# Joint European Standing Group (JESG) Requirements for Generators Stakeholder workshop feedback and Issues Log

National Grid

22nd February 2012

## V-Q- parameters for PPMs Offshore

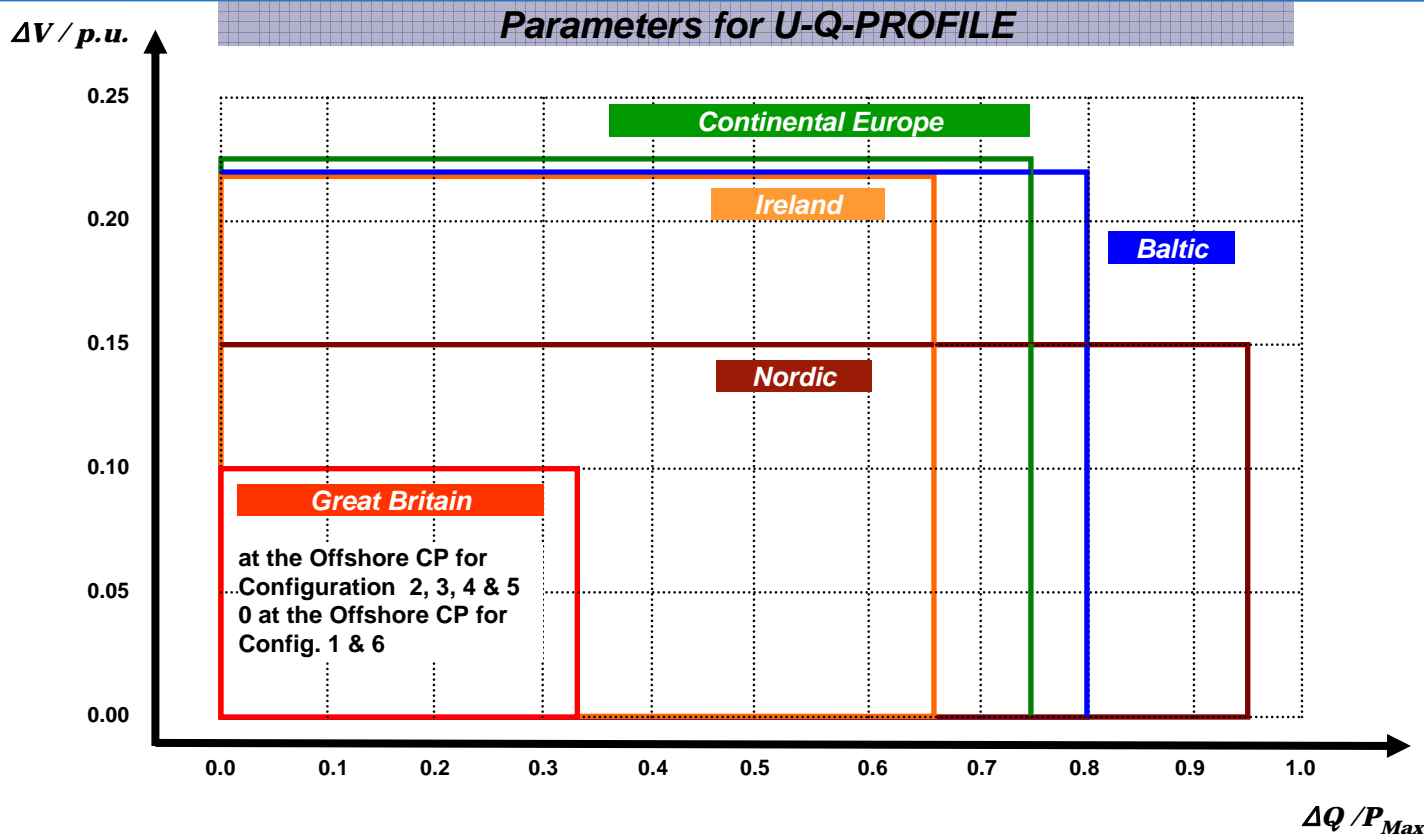
Q- The parameters for the reactive power range may be too inflexible and should therefore be future proofed

- 
- Considering the flexibility written into the code, this is a surprising statement.
  - We may not have understood fully the concern behind this question.
  - RfG has greater flexibility for Q than existing GB requirements
    - Balance between leading & lagging can be adjusted
    - V-Q shape can be selected
    - Both dimensions of freedom are in use within Germany
  - See the following slides for the requirements

One reason for GB difference is separate onshore reactive power requirement under the Offshore Transmission Network Owner (OFTO) regime

# Fault Ride Through capability

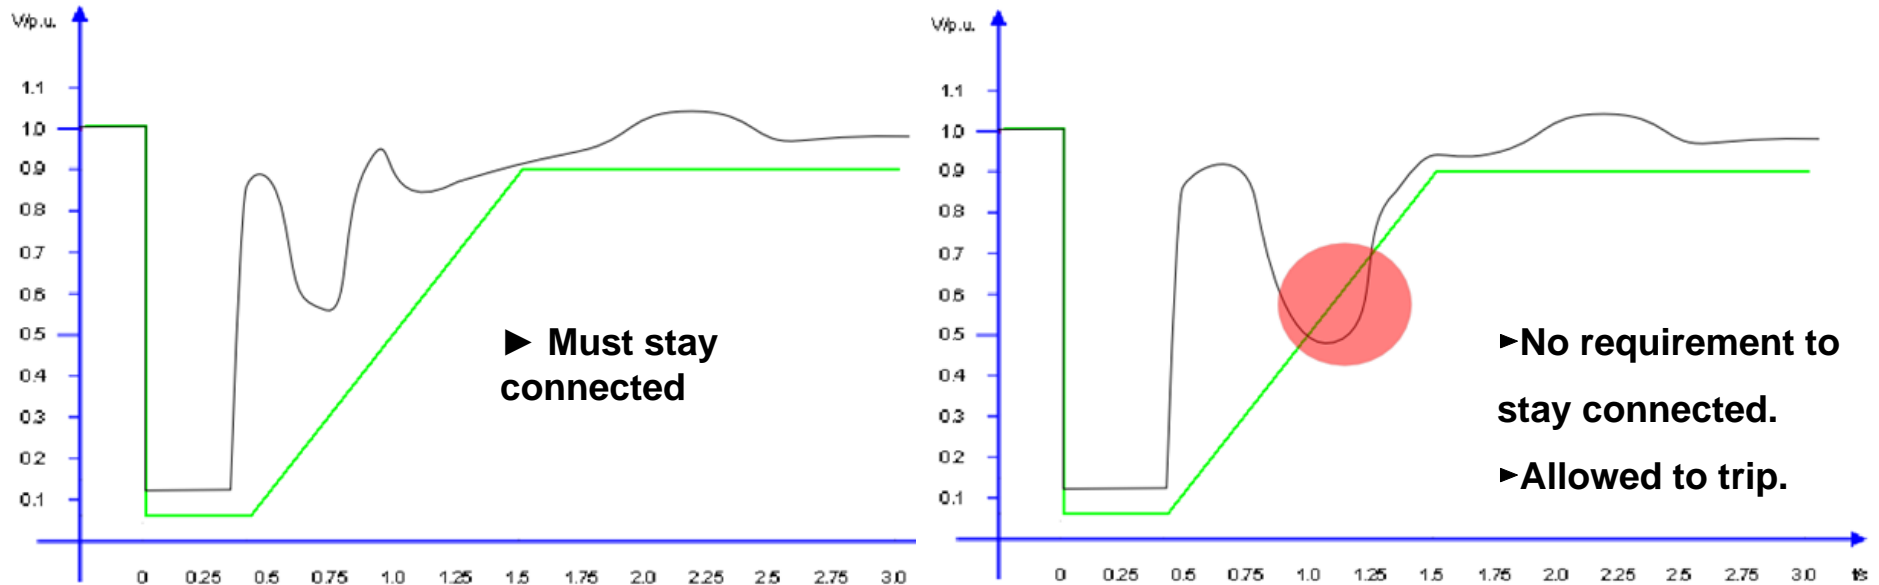
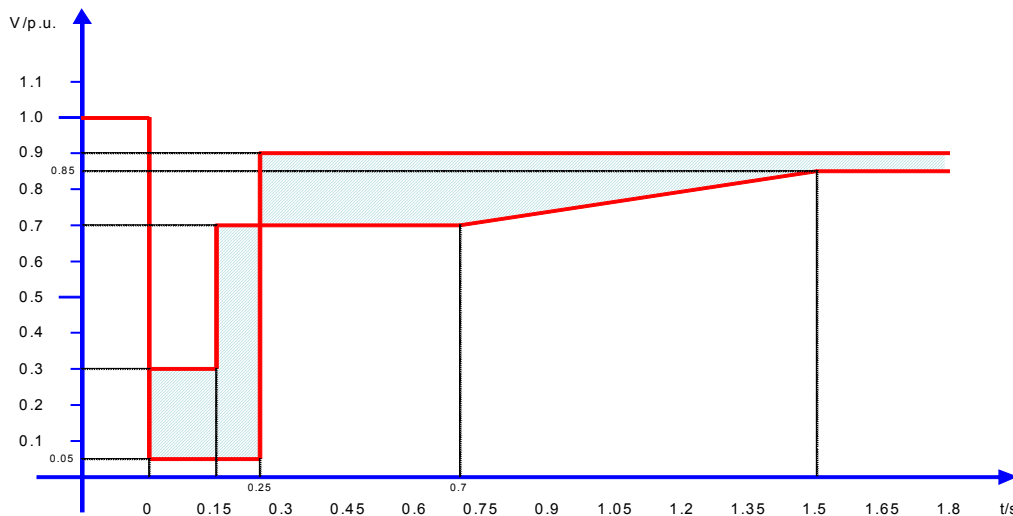
## Interpretation of requirement

### ***Assuming green curve selected in National code:***

- ~~“Stakeholder is responsible to ensure recovery V profile is above this green curve”~~
- ✓ No responsibility to deliver a voltage profile
- ✓ Requirement for unit to stay connected IF recovery voltage remains above.
